This sheet supersedes sheet 280. 3-24-60.

PIERS
BRIDGE NO. LAK-I-0226
UNDER STATE ROUTE NO. 91

LAKE COUNTY STA. 121+21.56

Sheet 6 of 10

HALF PIER ELEVATION

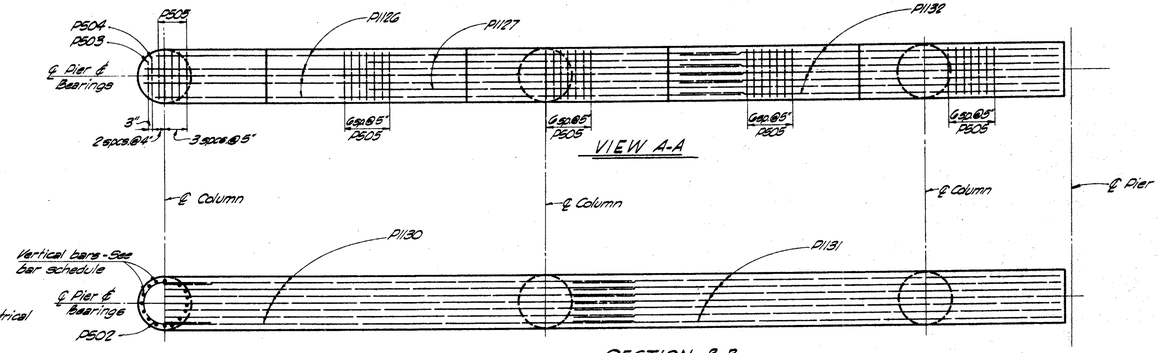
NOTE: For revised pier height provide the following reinforcing bars to lap with vertical column bars:

Pier No. 1: 96-#11 x 5'-1"
Pier No. 2: 96-#11 x 4'-11"
Pier No. 3: 96-#11 x 4'-9"
Pier No. 4: 96-#11 x 4'-7"
Pier No. 5: 96-#11 x 4'-5"

The length of the spiral bars to be increased to required change in height.

FOOTING PLAN
~~(Piers 1, 2, & 3 only)~~
(Piers 1, 2, 3 & three West Pads of Pier 4.)

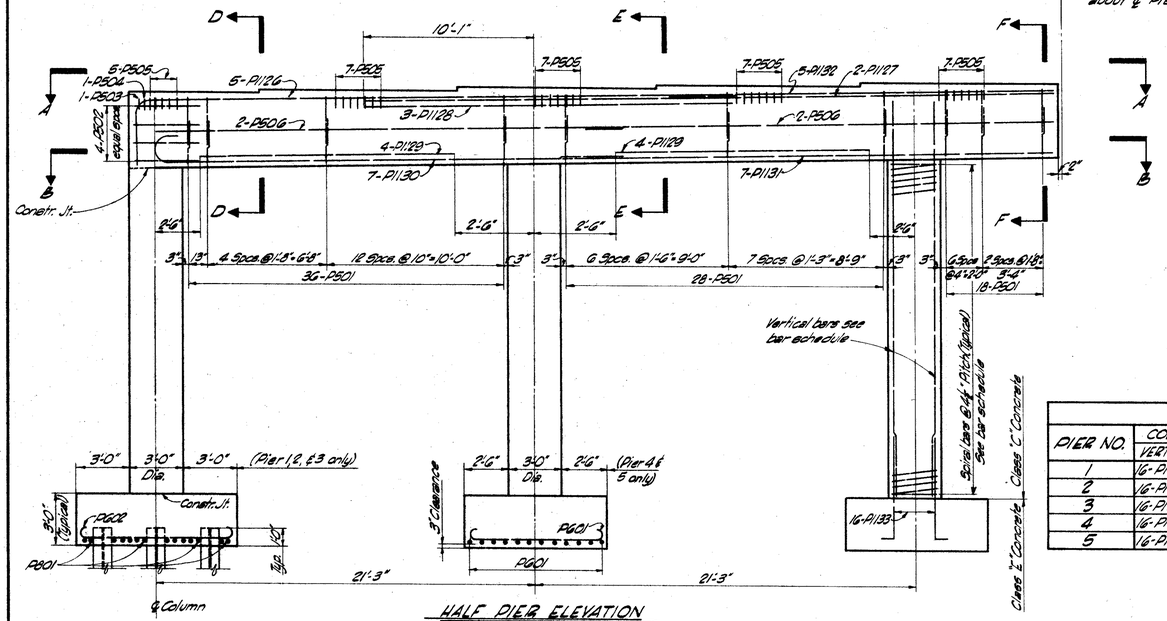
FOOTING PLAN
~~(Piers 4 & 5 only)~~
(Three East Pads of Pier 4 & Pier 5.)
